Memo

Re: Consultation on an Application

Planning Application Ref: PL/25/1667

Proposal: Application for Approval of Details Reserved by Conditions 5 and 6 of application PL/25/0342

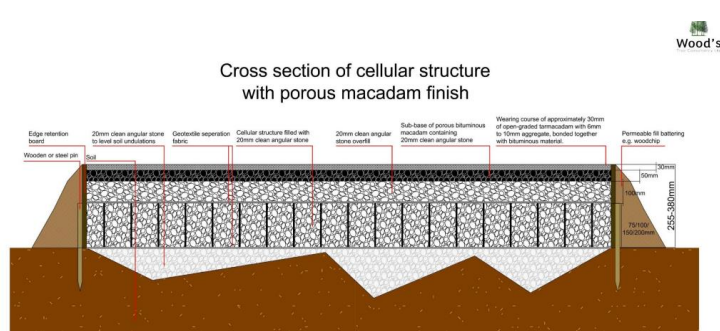
Tests were also done as follows '*to determine what rooting activity was likely to be foundation area where the play equipment is proposed within trees RPA. We conducted a soil removal as shown on the TPP drawing by the orange line this was to a maximum*

depth of 350mm. This was achieved using the recognised use of an 'Air Spade' to remove any issues of root damage occurring. The excavations were extremely difficult to achieve due to the ground composition of heavily compacted chalk with no rooting activity found. Only one root was exposed this has a diameter of 30mm.' It is certainly assuring minimal roots have been found in this area.

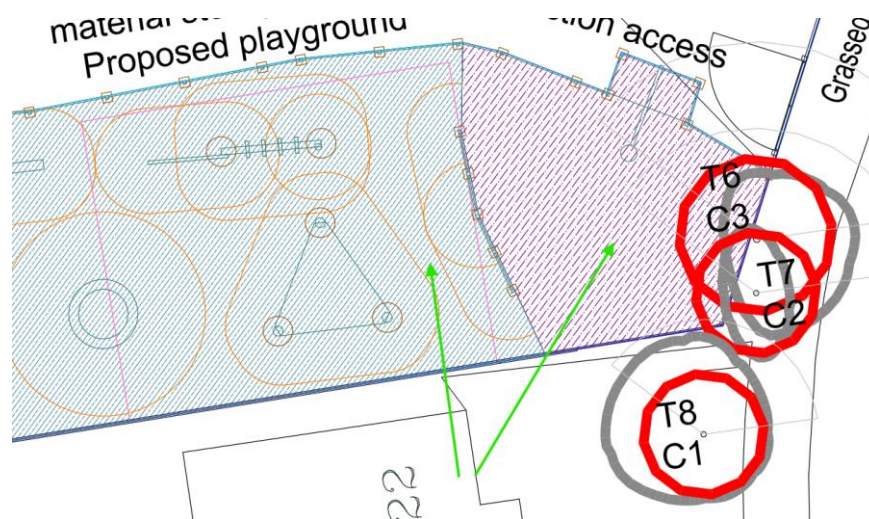
With reference to the Tree Protection Plan, 18th November 2025, Ref: WTC/TSPS/TPP/002, I am slightly unclear on the difference in surfacing shown below. Some clarity should be provided on this given the pink hatched area impacts T6 and T7 RPAs.
